Version Application:		Technical Service Bulletin Number:	
<input checked="" type="checkbox"/> CARB 04	<input type="checkbox"/> EPA 10	TSB-001	
<input checked="" type="checkbox"/> EPA 07 Upfit	<input type="checkbox"/> ADR 80/03	Released Date:	
<input type="checkbox"/> ADR 80/02		22-4-2010

Westport™ GX & LNG System Technical Service Bulletin

This Technical Service Bulletin has been prepared in conjunction with customer bulletin W1-SL-002 to provide instructions for the mandatory fuel shut-off valve upgrade for certain Westport vehicles. Westport has determined that a defect related to motor vehicle safety exists in certain Westport ISX G vehicles equipped with Liquefied Natural Gas pumps.

Figure 1: Components to be removed from tank

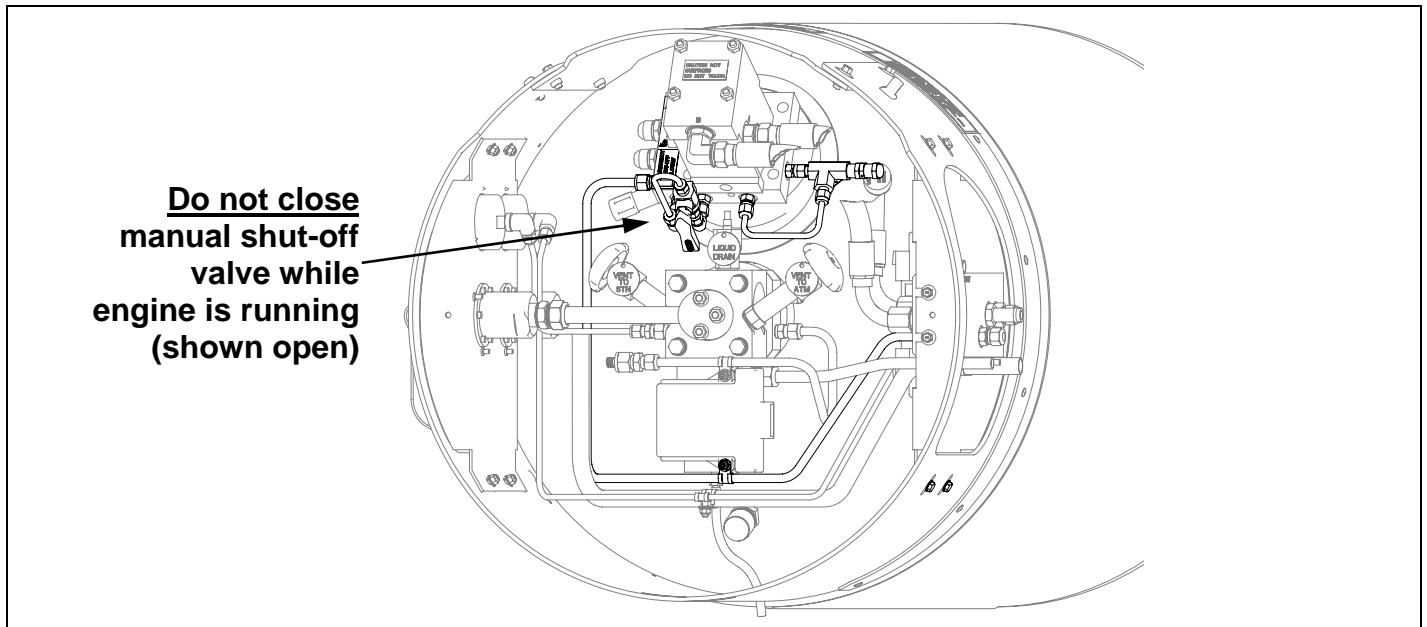
To prevent this condition from occurring, ensure that manual shutoff valve is **open at all times**, Figure 1. Communicate this information to all persons involved with the vehicle.

Figure 1: Components to be removed from tank (LHS tank shown)

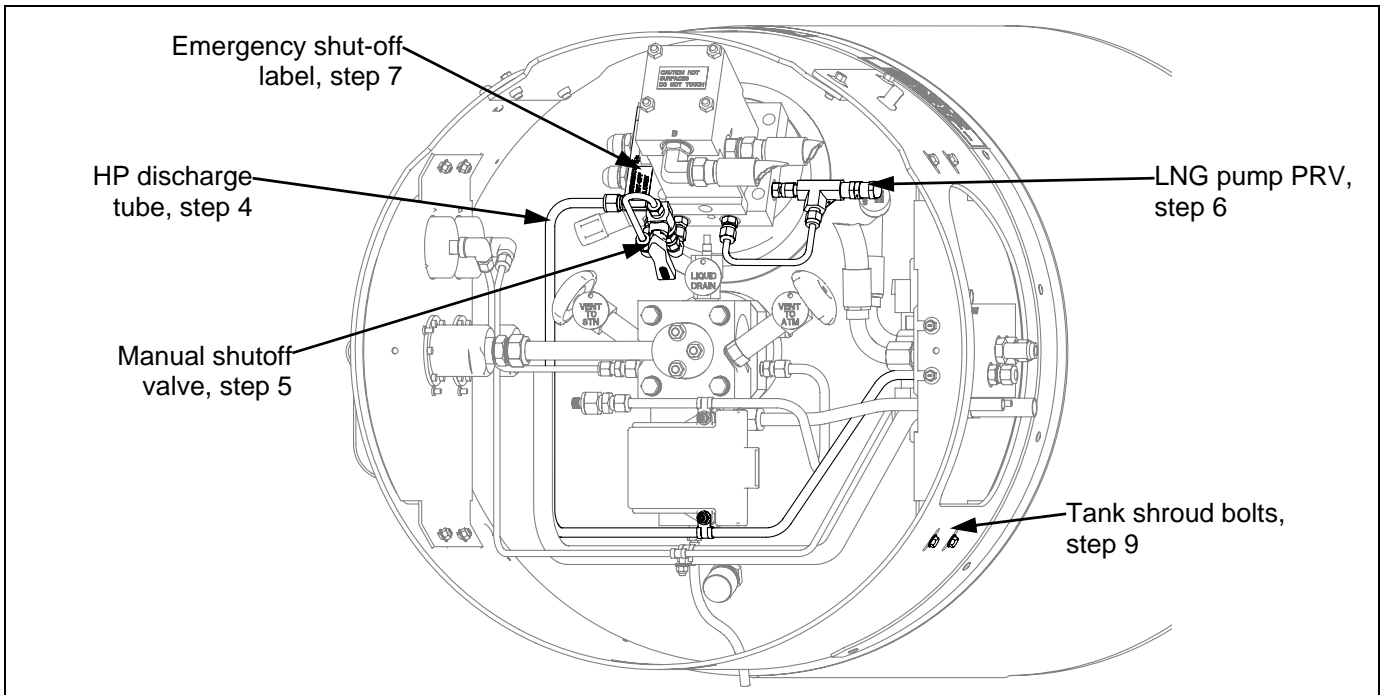
4. Remove the HP discharge tube including associated pump manifold fitting.
5. Remove the manual shut-off valve and associated tube and fittings.
6. Remove the pump pressure relief valve and associated tubing and fittings.
7. Remove the “Emergency Shut-off Closed” label from pump manifold.

Figure 3: LNG pump plug and fitting locations

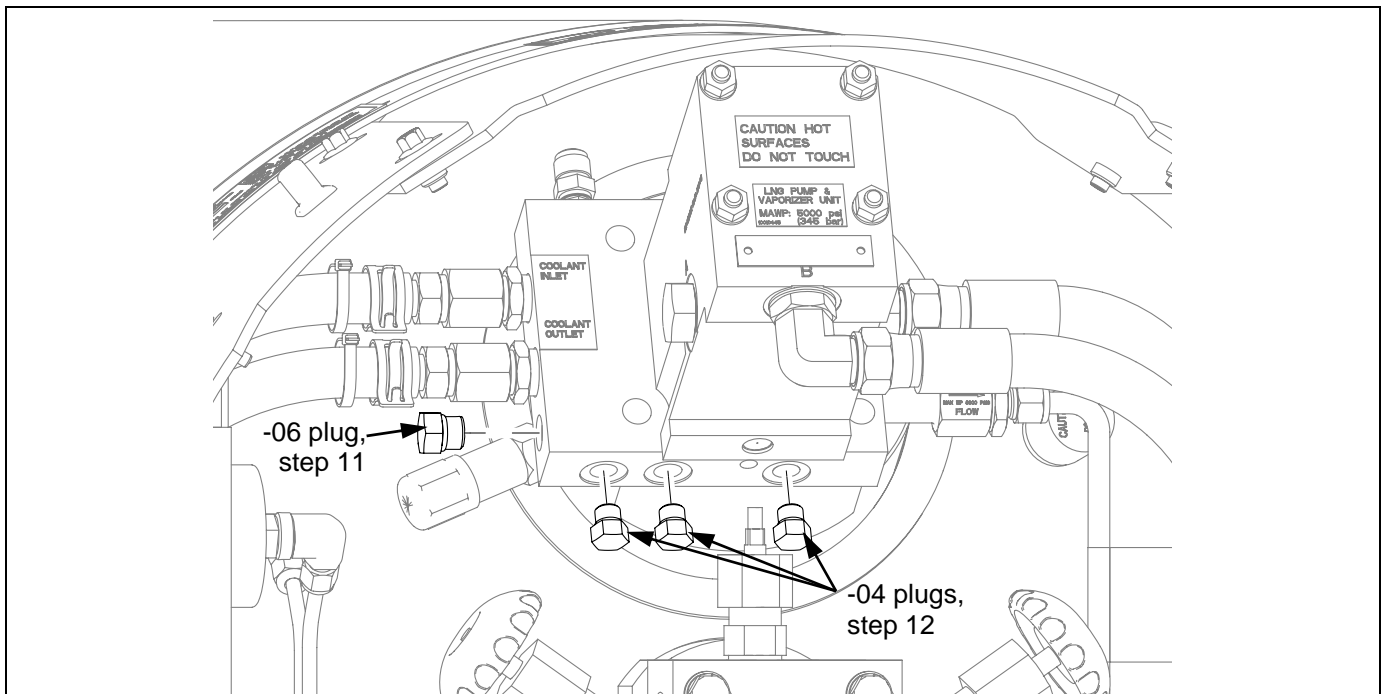
10. Before installing the provided port plugs (1x -06 plug and 3x -04 plugs): replace nitrile o-rings (black) with provided disogrin (white) o-rings and lubricate o-rings with clean 15W-40 oil. Ensure o-rings are in acceptable condition before installing (i.e. not twisted, nicked, torn or otherwise damaged).
11. Install the provided -06 plug with disogrin o-ring in the discharge tube port (Figure 3). Torque to **37 N·m (28 ft·lbs)**.
12. Install the three (3) provided -04 plugs with disogrin o-rings in the shutoff valve handle and PRV discharge tube fitting locations (Figure 3). Torque to **26 N·m (19 ft·lbs)**.

Figure 7: Installation location of regulator components and tube assemblies (LHS tank)

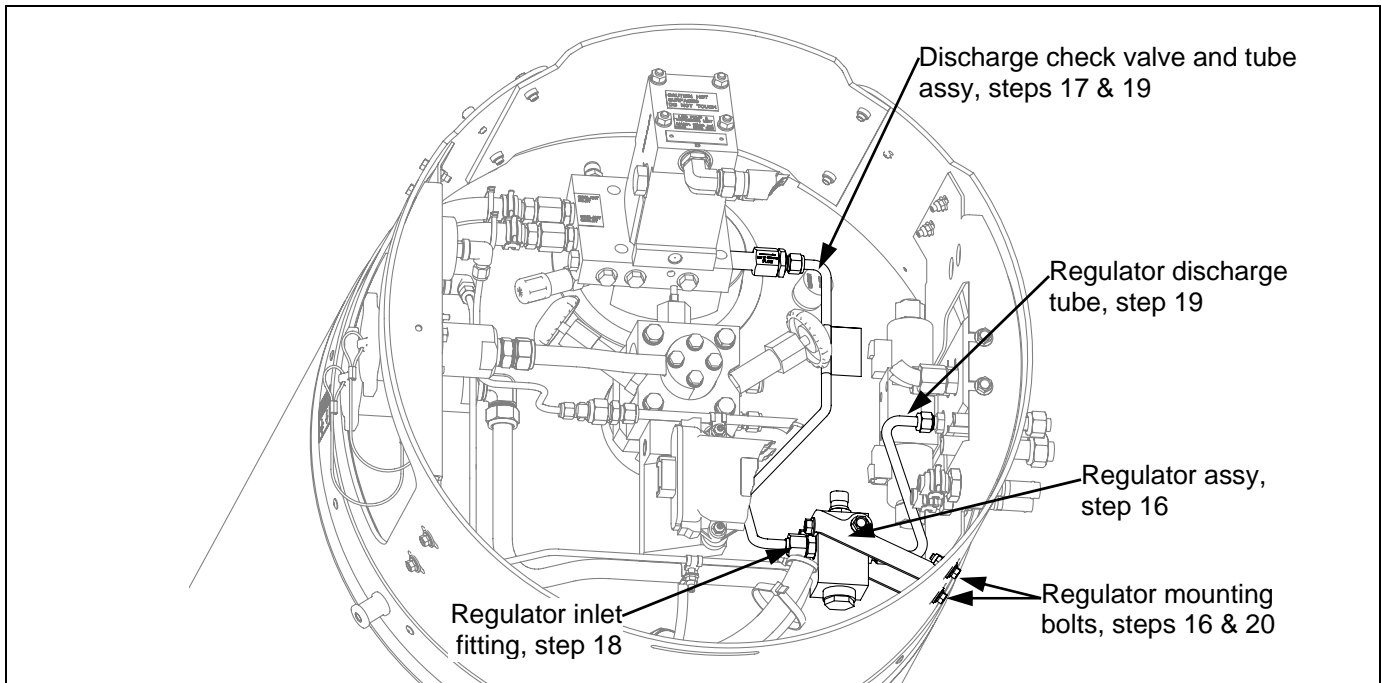
16. Fasten the regulator assembly loosely to the tank shroud using the provided mounting bolts, washers and nylok nuts (Figure 7).
17. Replace the check valve o-ring (black with yellow dot) with a provided disogrin (white) o-ring prior to installation. Then, loosely install discharge check valve and tube assembly between the LNG pump and the regulator assembly (Figure 7). Torque the check valve into the pump discharge port at **23 N·m (17 ft·lbs)**.

18. Tighten the LNG pump discharge tube to the regulator inlet o-ring face seal fitting **1/8th of a turn past finger tight** to ensure metal to metal contact (Figure 7).

19. Once the fit and alignment of the tubes, regulator assembly and check valve are acceptable tighten all tube fittings to **1/4 of a turn past finger tight** (Figure 7).

20. Torque regulator mounting bolts to **9 N·m (17 ft·lbs)** (Figure 7).
21. Install the M14 hex head plug with disogrin o-ring from Step 12 into the temperature sensor port on the bottom of the hydraulic manifold.

Figure 8: Installation location of regulator components and tube assemblies (RHS tank)

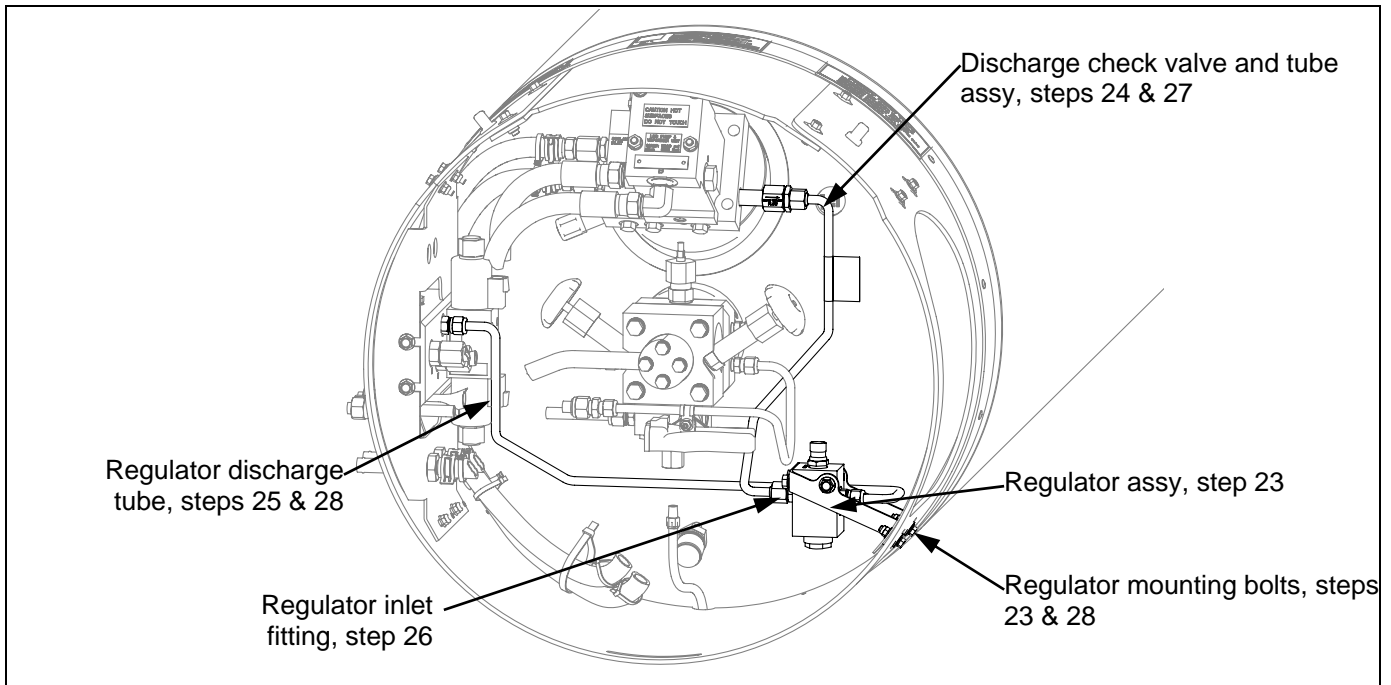
23. Fasten the regulator assembly loosely to the tank shroud using the provided mounting bolts, washers and nylok nuts (see Figure 8).
24. Loosely install the pump discharge check valve and tube assembly between the LNG pump and regulator assembly. Torque the check valve into the pump discharge port at **23 N·m (17 ft·lbs)**.
25. Loosely install the discharge tube between the regulator and the hydraulic manifold.
26. Tighten the LNG pump discharge tube to the regulator inlet o-ring face seal fitting **1/8th of a turn past finger tight** to ensure metal to metal contact.
27. Once the fit and alignment of the tubes, regulator assembly and check valve are acceptable, tighten all tube fittings to **¼ turn past finger tight**.
28. Torque regulator mounting bolts to **9 N·m (17 ft·lbs)**

Figure 9: Accumulator check valve configuration (ADR80/02 build shown with check valve still installed).

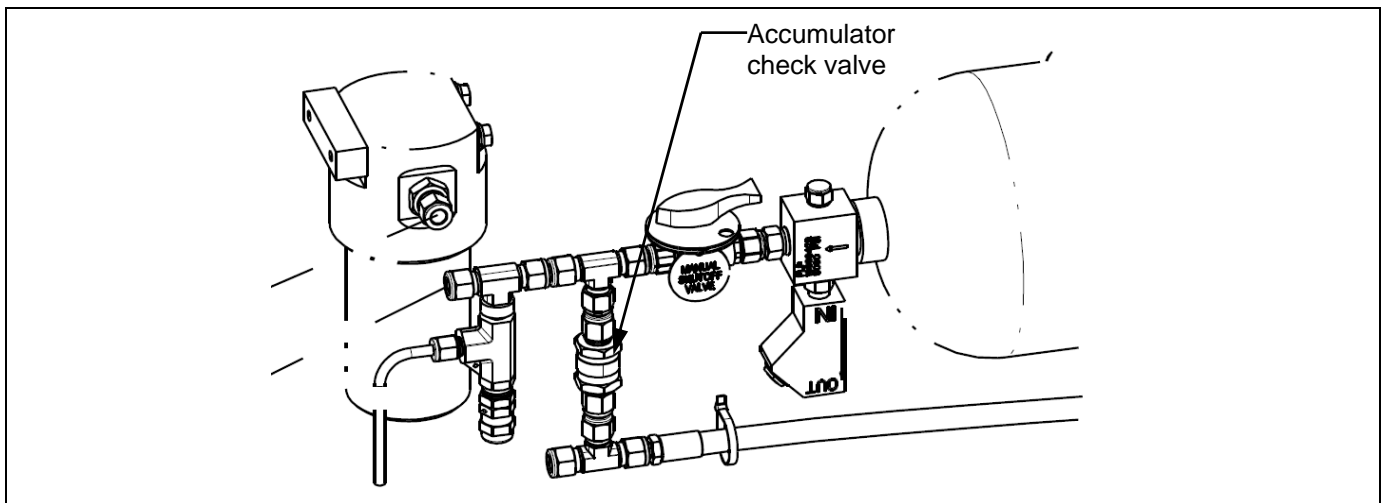
- 29. Remove the check valve found near the accumulator. An example of this valve is shown in Figure 9 although other configurations are possible.
- 30. Install provided length of tubing between nearest fittings/hose to replace the check valve. Install tubing in accordance with Swagelok *General Guidelines for Tube Bending*, Swagelok *General Guidelines for Tube Fitting* and Westport Work Instruction *INS-10011729 General Guidelines for Fittings Installation*.
